# Access Compliance Report

## Public Rights-of-Way

Intersection ID: 3786	Main Street: GALLOWAY_RD	Cross Street: MALLARD_CREEK_RD	Location: N
ADA ID: 6F4E842D472F	Ramp Type: Perp	Initial Pass/Fail: Fail	Overall Compliance: No
Severity Score: 21.25			
Codes/Mitigation Info/Possible Solution		Field Measurements/Component Compliance

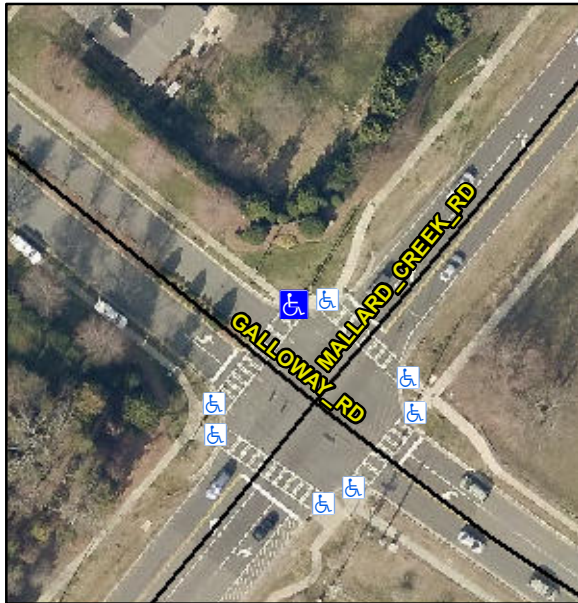
**Remove & Replace Entire Ramp.**

**R304.5.1, R304.2.2**

Compliance	Description	Data	Compliance	Description	Data
N/A	Ramp Length (in)	71.0	No	Ramp Slope (%)	8.8
No	Ramp Width (in)	46.5	Yes	Ramp XSlope (%)	1.0
N/A	Flare Type LT	N/A	N/A	Flare Type RT	N/A
N/A	Flare Slope LT (%)	N/A	N/A	Flare Slope RT (%)	N/A
N/A	Flare Traversable LT?	N/A	N/A	Flare Traversable RT?	N/A
N/A	Landing Length (in)	N/A	N/A	DWS Provided?	N/A
N/A	Landing Width (in)	N/A	N/A	DWS Contrast?	N/A
N/A	Landing Slope (%)	N/A	N/A	DWS Length (in)	N/A
N/A	Landing X Slope (%)	N/A	N/A	DWS Full Width?	N/A
N/A	Landing Curb? (Y/N)	N/A	N/A	DWS Offset (in)	N/A
N/A	Shared Landing?	N/A			
N/A	Gutter Ponding?	N/A	N/A	Gutter Slope (%)	N/A
N/A	Gutter Lip Ht (in)	N/A	N/A	Gutter X Slope (%)	N/A
N/A	Painted X Walk1?	Yes	N/A	Painted X Walk2?	N/A
	X Walk 1 Direction	To SW		X Walk 2 Direction	N/A
N/A	X Walk 1 Width (in)	112.0	N/A	X Walk 2 Width (in)	N/A
	X Walk 1 Slope (%)	4.4		X Walk 2 Slope (%)	N/A
	X Walk 1 X Slope (%)	0.9		X Walk 2 X Slope (%)	N/A
